Final Drainage Report

Ellicott School Addition - 2 Buildings

Project No. 61183

PCD File No. PPR-22-50

11 Report Maps

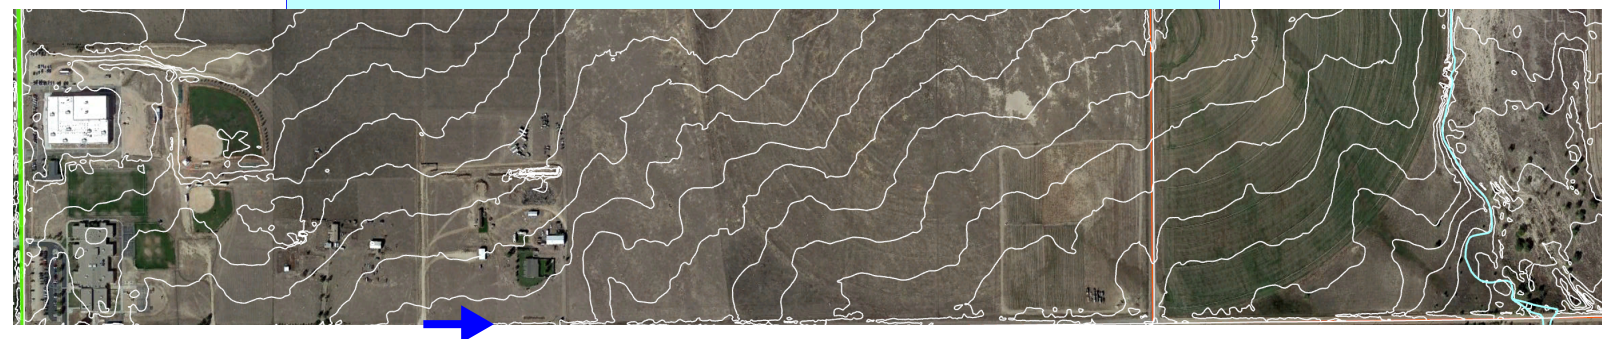
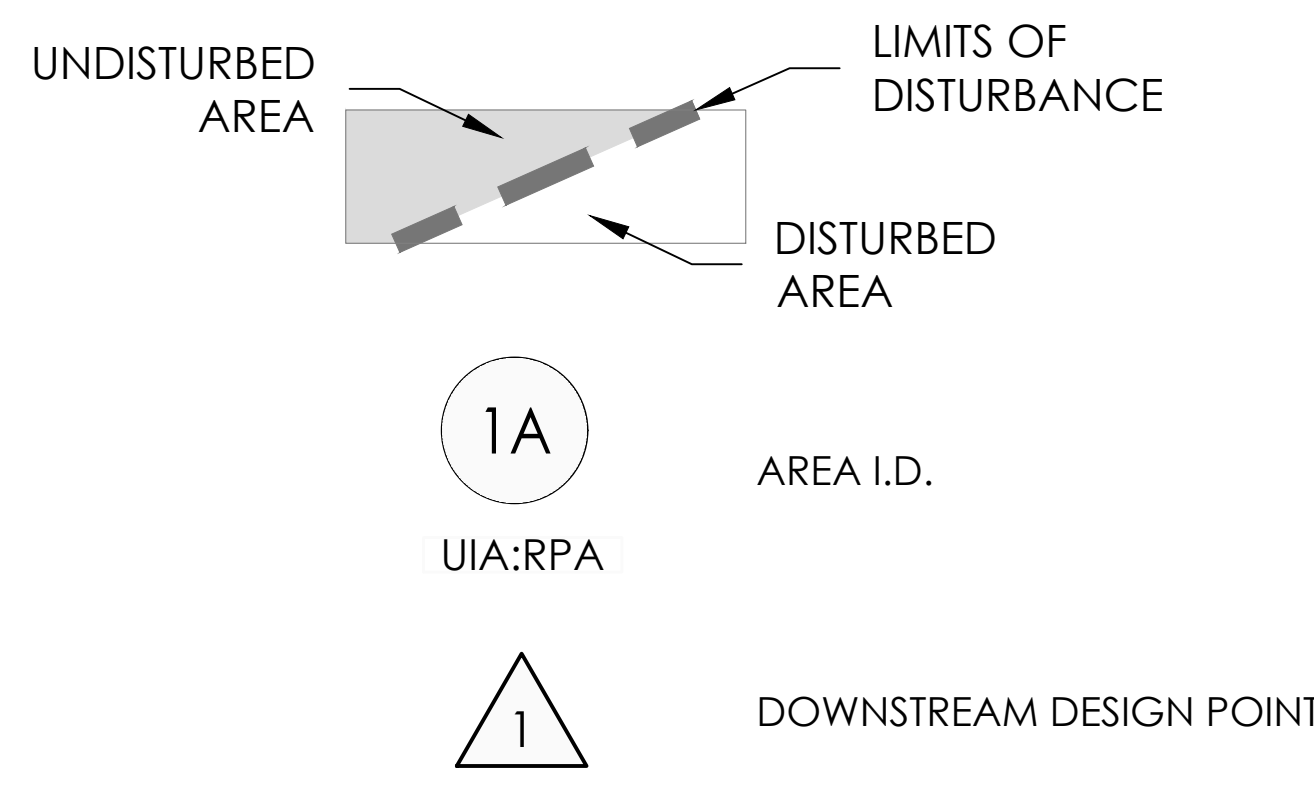
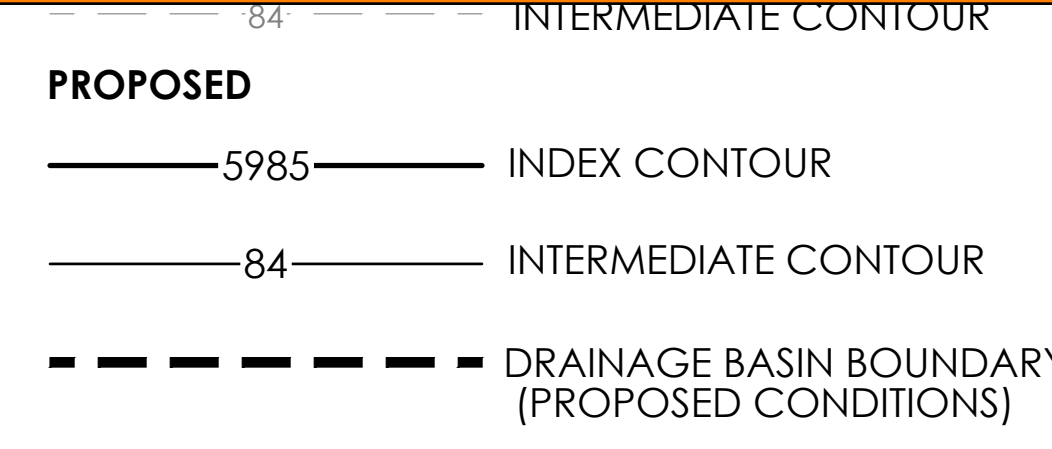
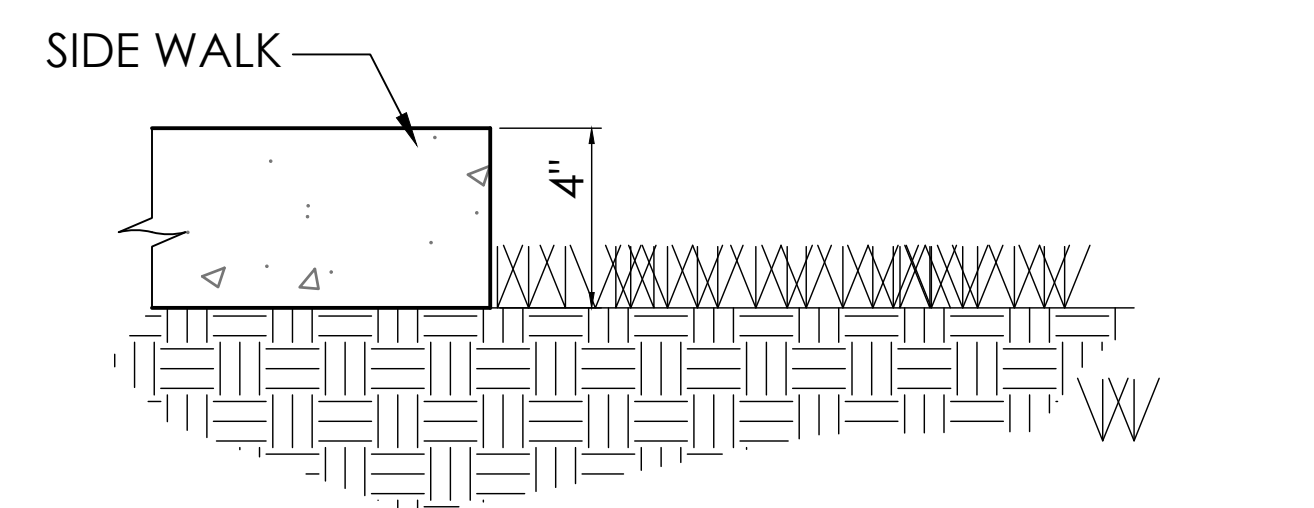
Please provide an overall reference map showing the overall property and indicating the outfall and downstream conveyance location.

General comment about WQ for the whole site:
 1) all areas within the LOD must be shown as having either WQ treatment or WQ exclusion. This has not been done on your maps yet. Show LOD on all WQ maps.
 2) Between these BMP Area ID Maps (runoff reduction) and PBMP Tributary Maps (rain gardens), there is double treatment shown for many areas. Please make the overall WQ picture for this site more clear by removing all areas treated by the rain gardens from the RR maps (ie: make another color on this map for "treated by rain gardens") and update the RR calc spreadsheet and report text.
 3) Please review MHFD Detail T-0. There appears to be a misunderstanding of what constitutes a DCIA.

Just for reference, the above comments are provided as further clarification to my previous comment (copied below in italics) that were not fully addressed with this submittal, so this isn't a new request. Plus so much of the design has changed since the last submittal (all runoff reduction calcs and maps are new), I am now able to clarify my previous comment further.

It is unclear which disturbed areas (and how much acreage) area not conveyed to the Rain Gardens. We need to know how much disturbed area is untreated and if there are any exclusions that apply to those areas.

So please create a basic overview map (or modify an existing drainage map) with color shading/hatching that shows areas tributary to each PBMP (pond, runoff reduction, etc) and those disturbed areas that are not treated by a PBMP, with the applicable exclusion labeled (ex: 20% up to 1ac of development can be excluded per ECM App I.7.1.C.1 and exclusions listed in ECM App I.7.1.B.#).

MVE PROJECT 61183
MVE DRAWING PBMP-TRIB-I

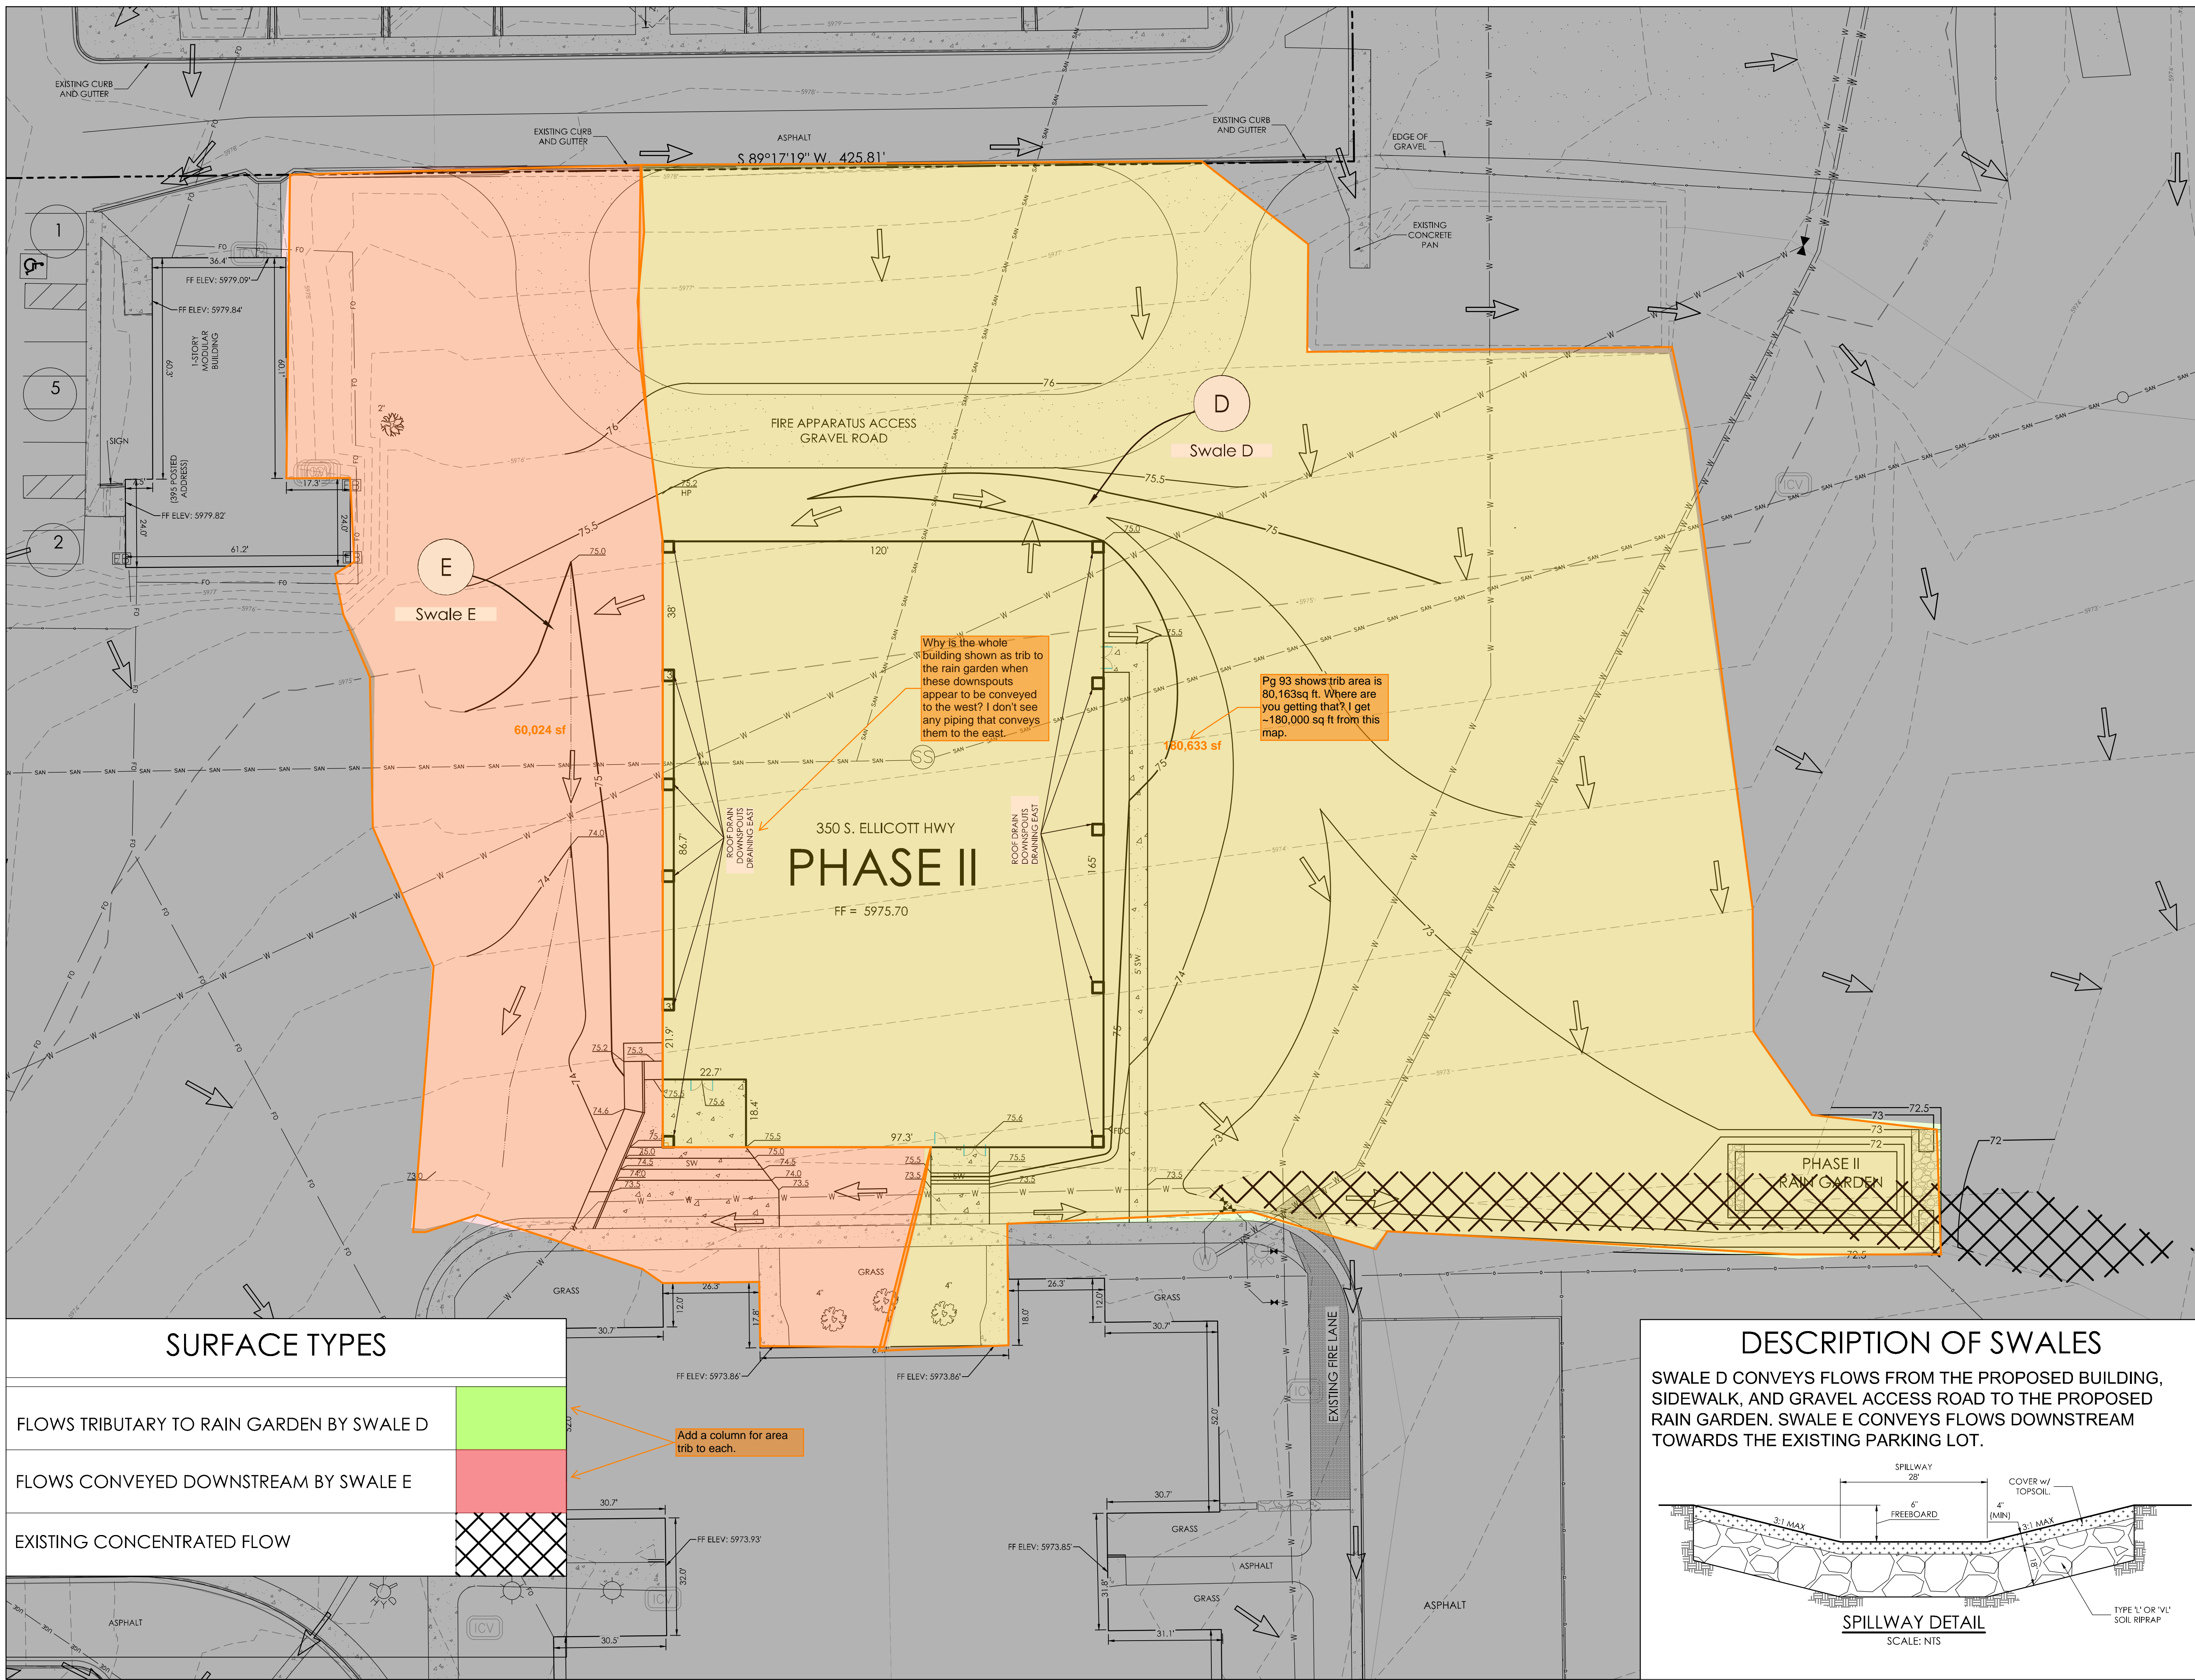
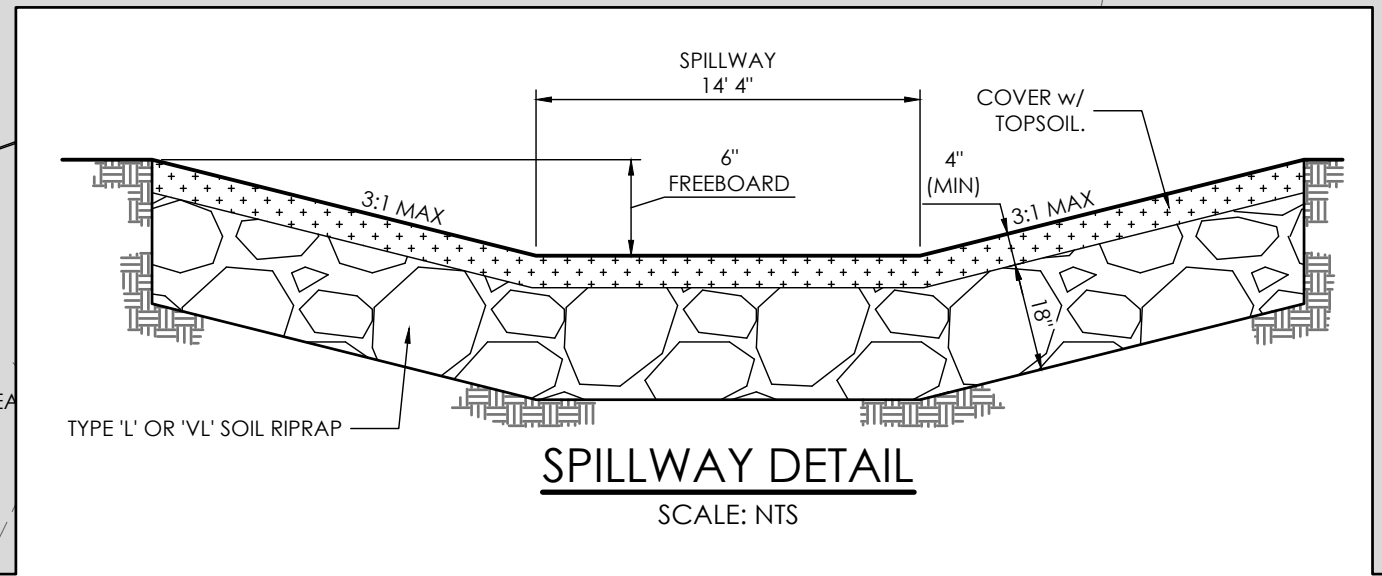
Add a column for area trib to each.
